DEPARTMENT OF TRANSPORTATION

Quality Assurance and Source Inspection

Contract #: 04-0120F4Cty: SF/ALA Rte: 80 PM: 13.2/13.9File #: 69.28**WELDING INSPECTION REPORT****Resident Engineer:** Siegenthaler, Peter**Address:** 333 Burma Road**City:** Oakland, CA 94607**Report No:** WIR-016971**Date Inspected:** 22-Sep-2010**Project Name:** SAS Superstructure**OSM Arrival Time:** 700**Prime Contractor:** American Bridge/Fluor Enterprises, a JV**OSM Departure Time:** 1900**Contractor:** Zhenhua Port Machinery Company, Ltd (ZPMC), Changxing Island **Location:** Shanghai, China**CWI Name:** Qiu Wen**CWI Present:** Yes No**Inspected CWI report:** Yes No N/A**Rod Oven in Use:** Yes No N/A**Electrode to specification:** Yes No N/A**Weld Procedures Followed:** Yes No N/A**Qualified Welders:** Yes No N/A**Verified Joint Fit-up:** Yes No N/A**Approved Drawings:** Yes No N/A**Approved WPS:** Yes No N/A**Delayed / Cancelled:** Yes No N/A**Bridge No:** 34-0006**Component:** Tower & OBG Components**Summary of Items Observed:**

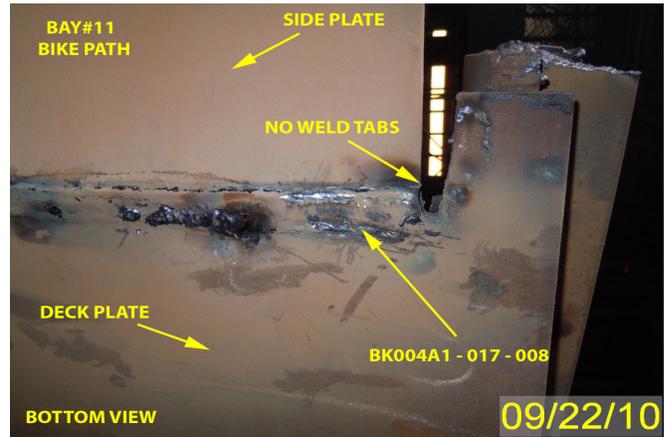
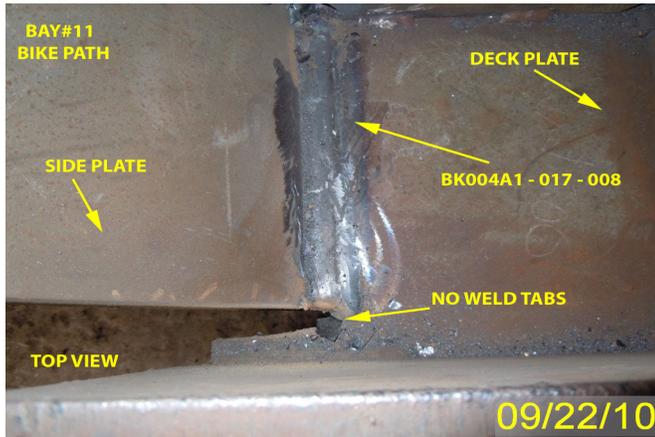
-ZPMC personnel performed welding of CJP butt weld joint on Bike Path BK004A-017, without using the weld tabs at both ends.

-The weld is a complete joint penetration (CJP) Butt joint, joining the Bike Path side plate (BKPL3B) to the Top Plate (BKPL2A).

-The weld is identified as BK004A1 – 017 # 008.

AWS D1.5 2002 section(s): 3

3.12.1 “Welds shall be terminated at the end of a joint in a manner that will ensure sound welds. Whenever possible, this shall be done by use of weld tabs (extension bars and runoff plates) placed in a manner that will duplicate the joint detail being welded.”
